From: [Blumenfeld, Jared](#)
To: [Ebbert, Laura](#); [Goforth, Kathleen](#); [Horst Greczmiel](#)
Subject: Fw: Rosemont Mine Project
Date: Friday, January 31, 2014 11:28:54 AM
Attachments: [UN Declaration on the Rights of Indigenous Peoples 04262012.pdf](#)

The following objections to the Forest Service's documents entitled "Final Environmental Impact statement for the Rosemont Copper Project" (December 2013) and the "Draft Record of Decision and Finding of Nonsignificant Forest Plan Amendment for the Rosemont Copper Project" (December 2013) are being jointly submitted by Pima County and the Pima County Regional Flood Control District. For purposes of the objections, "Pima County" or "County" refers to both Pima County and the Pima County Regional Flood Control District.

"ROD" means the document entitled "Draft Record of Decision and Finding of Nonsignificant Forest Plan Amendment for the Rosemont Copper Project" (December 2013).

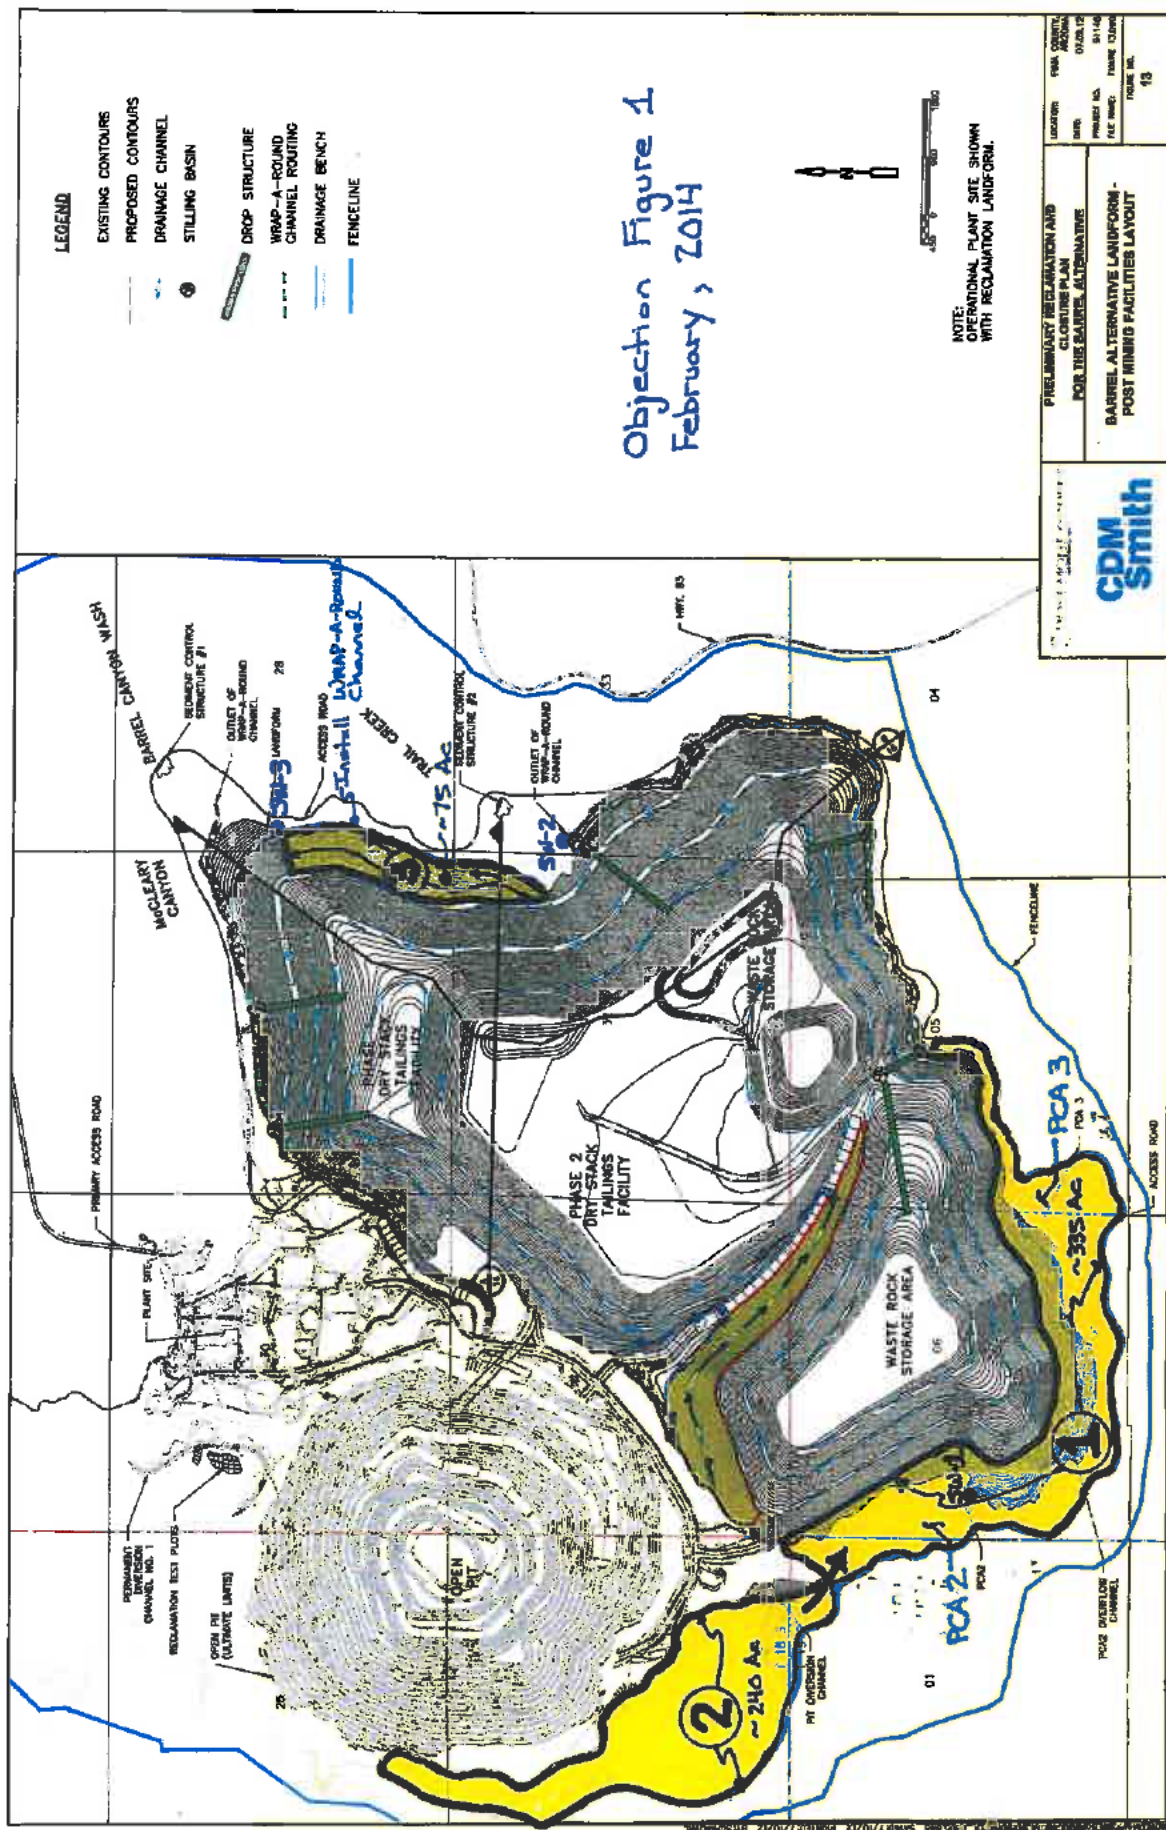
Objection Figure 1 (February 2014) is based on Figure 13 (Barrel Alternative Landform) of the CDM Smith *Preliminary Reclamation and Closure Plan* (July 2012). As shown on Objection Figure 1, stormwater which is intended to be collected and retained in PCA2 and PCA3 includes contributions from: the lower slopes of the Waste Rock mound and adjacent upper slopes of the Barrel Canyon watershed (Area 1), and the entire upgradient watershed area associated with the Pit Diversion Channel (Area 2). Area 1, comprising the area which is not planned for downstream drainage between the Waste Rock mound and the upper Barrel Canyon watershed divide, has a surface area of about 335 acres. Area 2, consisting of a mountainous watershed which sheds surface water to the Pit Diversion Channel for transfer into Area 1, has a surface area of about 240 acres with an approximate 100-yr discharge of 1800 cubic feet per second. Combined, Areas 1 and 2 have a watershed surface area approaching 1 square mile in size.

The Forest Service should require Rosemont Copper to professionally design and construct a stormwater management channel along the southern perimeter of the Waste Rock mound to collect and transmit surface waters from the Pit Diversion Channel (Area 2 on Objection Figure 1), and the lower side slopes of the Waste Rock mound and adjacent upper Barrel Canyon watershed (Area 1 on Objection Figure 1). The stormwater management channel would transfer these surface waters into the FEIS Wrap-A-Round channel alignment located at the east end of Area 1 (Objection Figure 1). From this point, the collected surface waters

There is sufficient grade for a continuous perimeter stormwater channel from PCA2 all the way around to the Trail Creek outlet at location SW-2. As shown on Objection Figure 1, the Waste Rock mound perimeter distance from Point SW-1 (elev ~ 5220 msl) to Point SW-2 (elev ~ 4820 msl) is about 20,000 ft, with a corresponding elevation drop of about 400ft. This corresponds to an average slope of approximately 2% for the perimeter system.

As shown on Objection Figure 1, there is no collection channel planned to transfer water collected at the base of the Area 3 sideslope interval. An additional wraparound or perimeter channel should be constructed at this location along the northeastern side of the Tailings mound. Instead, stormwater collecting from this approximate 75 acre watershed side slope simply ponds along the base of the sideslope, within three main tributary areas below the adjacent north-trending ridgeline. This situation is similar in nature to the trapped water in PCA 2 and PCA 3 as described above in Objection 1.

The Forest Service should require Rosemont Copper to professionally design, and construct, an approximate 5000 ft long stormwater management channel along the northeastern perimeter of the Tailings mound to collect surface waters from the lower eastern side slope (Area 3 on Objection Figure 1). Surface waters collected along the base of this slope should be routed to the tailings mound side slope stormwater channel shown at location SW-3, for transfer into the northern Wrap-A-Round channel and release in perpetuity at the channel outlet into downstream Barrel Canyon.
